MEMORANDUM

SUBJECT: P-1112 Amendment List - Notes for Bidding

Below is the P-1112 amendment list that is intended to inform clarify several items for all bidders of The Desalination plant.

Figure 1 (Refer to Item 12)

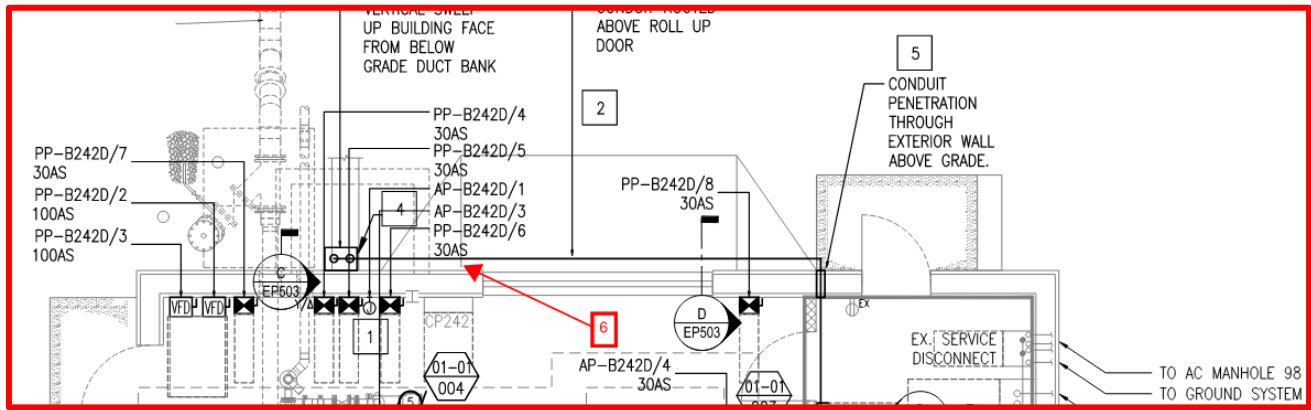
13. Pump Room A Process Floor Plan Drawing D-102:

- a. 1. Limits of in-scope vs out of scope. The red Line indicates the new limit of the Scope of work for the contract. Note that PP-B242D, XFMR-APD242D and AP-B242D are included in this contract. (See Figure 1 at the end of this Memo.)
- b. 2. The note "NEW PARTITION WALL" (C-4 on Drawing D-102) Should be Replaced with " PROVIDE PARTITION WALL – SEE DRAWING S-122 DETAIL A FLOOR PLAN"
